BID: CPST-14
I-95 Loop Project
Streetscape Phases 1B & 1E

ADDENDUM 1
DATED: JANUARY 22, 2019

The following questions have been submitted for clarification:

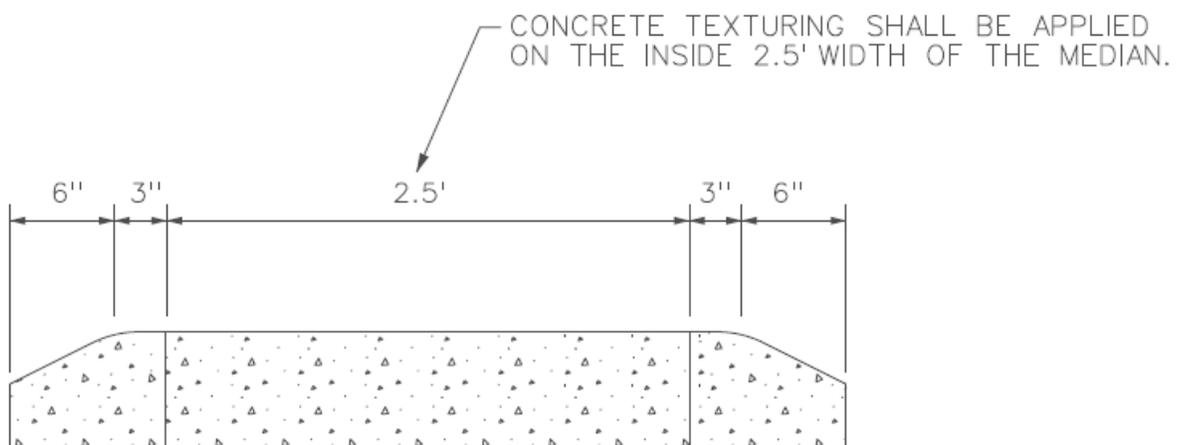
- 12) Raised Concrete Median. Notes say refer to page 5 for detail. Can you provide more information/detail? Is the entire median colored? Can you show brick detail in relation to the edge of median? **Answer:** See detail below. The entire median is colored. The texturing shall be applied on the inside 2.5' width of the median.
